Hi-Fi Products
Service Bulletin

Model: STR-GX5ESI I

No. 124

Subject: Static Noise Heard Through
The Speakers

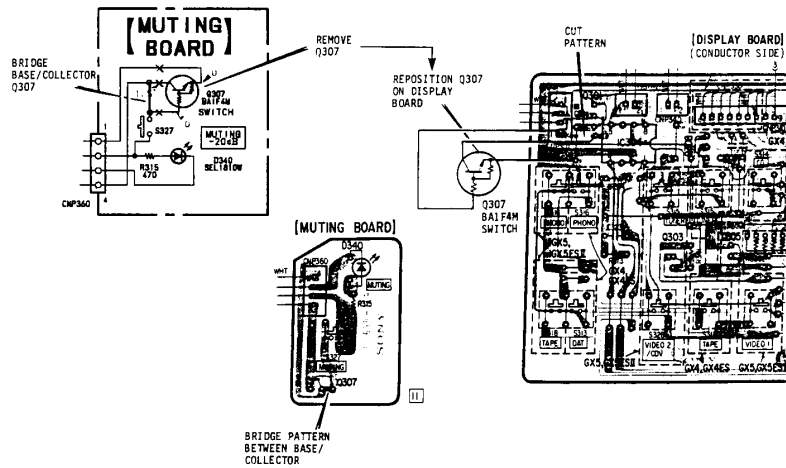
Noise is generated with the volume knob in the center position.

Solution: Move muting transistor from muting board to display board. This eliminates the connecting cables, and eliminates the noise, as the noise is radiated by the display board and picked up by the cables.

- o Muting Board
 - Remove Muting Transistor Q307
 - Bridge the Base and the Collector.
- o Display board
 - Cut the pattern directly behind Pin 4 of Connector CNP301
 - Install Muting Transistor Q307 on the Conductor side as shown.
